Site evaluation of completed County Cost Share Projects

Lake: Crescent Lake

Site Visit Follow Up: 07/27/2021 by Baerbel Ehrig, Oneida County Land & Water Conservation Department

Figure 3

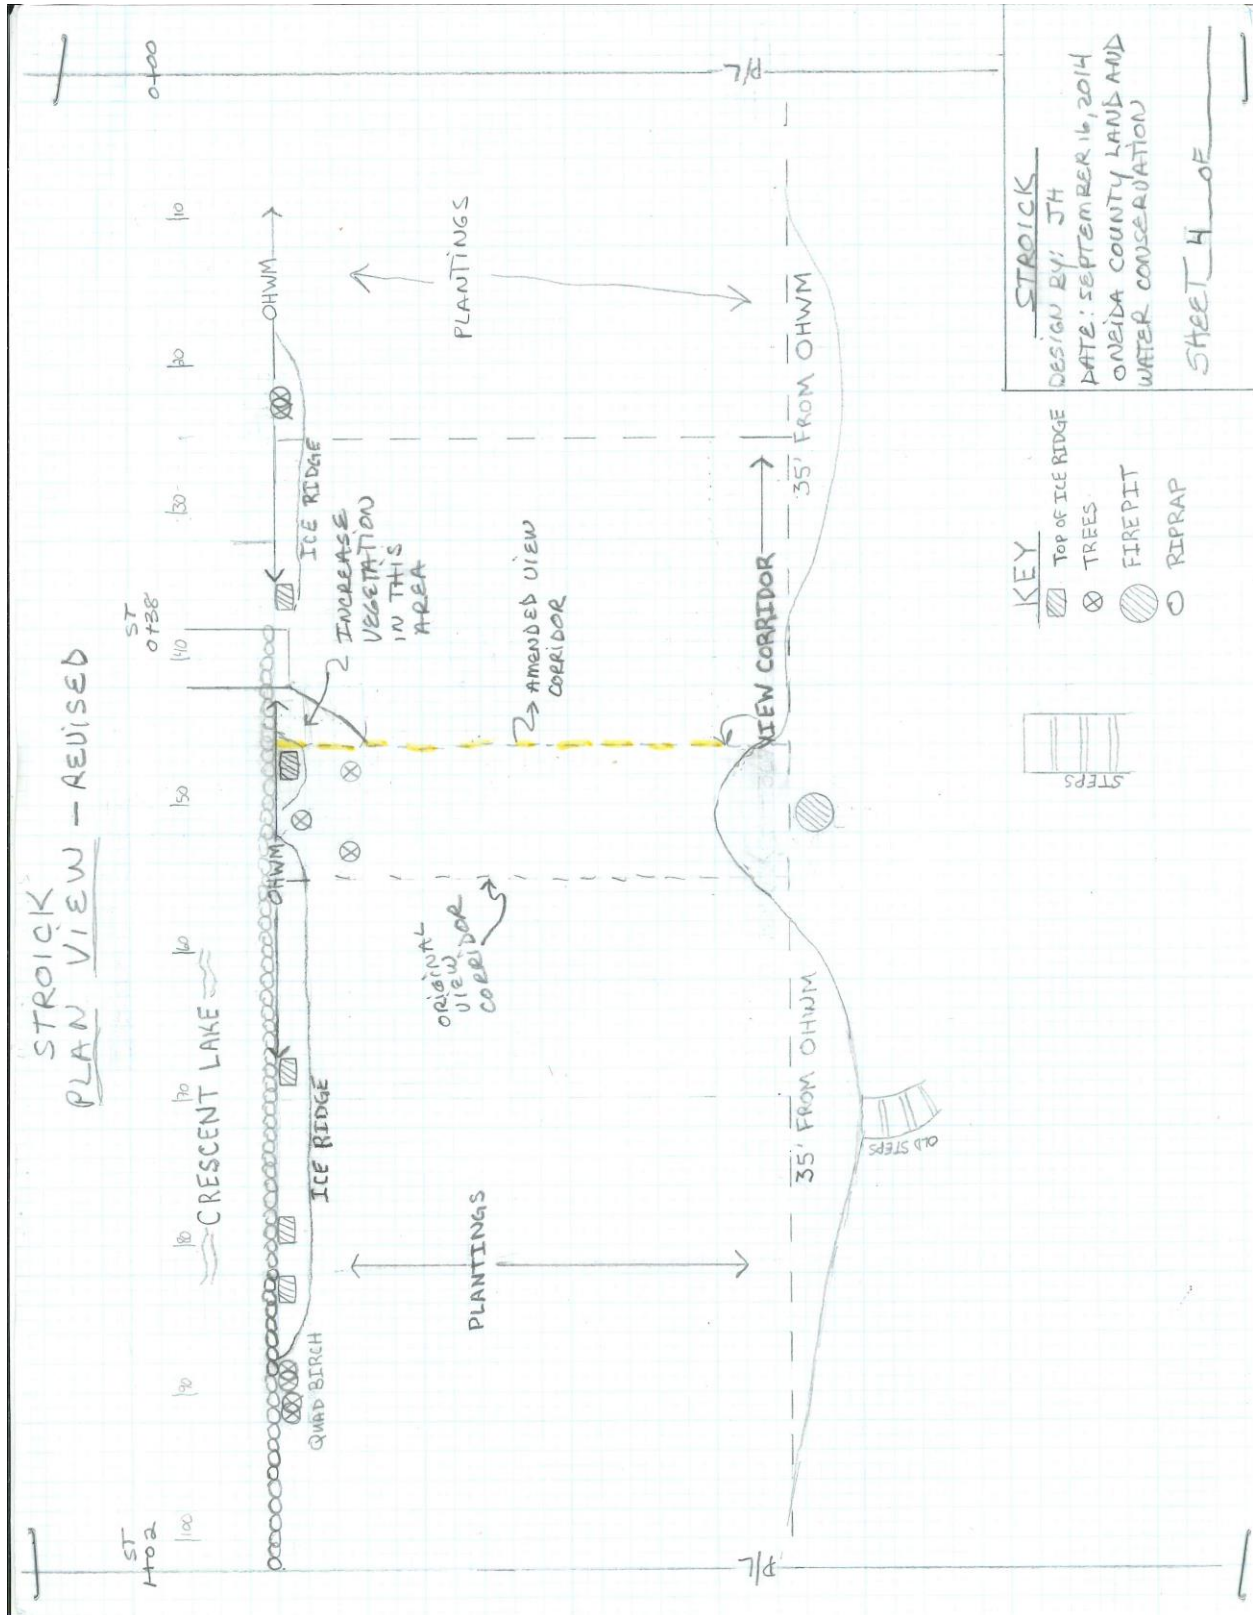
Upon further review of the plan in the office, it appeared that the view corridor line has been moved towards the “left”. According to the construction plan the view corridor line should be roughly where the red line is in Figure 3. Please see Figure 4 for more information. The native planting border according to the plan is also roughly where the red line is located.

The home owner signed a contract to maintain the project areas for 10 years. We therefore need to ask for the area to the left of the red line, which is now showing lawn, to be restored to a native planting area. We recommend a total of 40 plant plugs. Choose a mix of Black Eyed Susan, Beebalm, New England aster, Barren strawberry, Wild Columbine. For any questions or concerns please contact me at behrig@co.oneida.wi.us or call the office at 715 369 7835.
